Access Compliance Report Public Rights-of-Way (Curb Ramps)

Intersection ID: 43865 Main Street: SIDNEY CREST AV Cross Street: STONE TRAIL RD Location: **Overall Compliance: No** ADA ID: F0B010B12A40 Ramp Type: BlendTrans1 Initial Pass/Fail: Fail Severity Score: 21.25

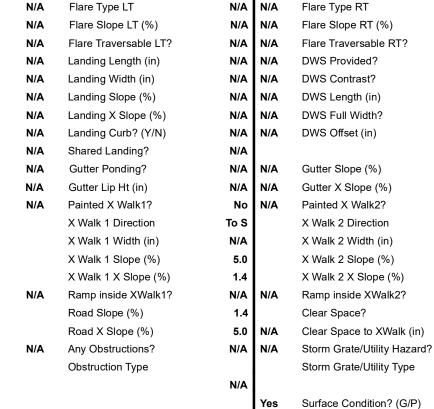
Not Found, R304.5.1, R304.5.3

Remove & Replace Curb Ramp With Two New Directional Ramps or Equivalent.
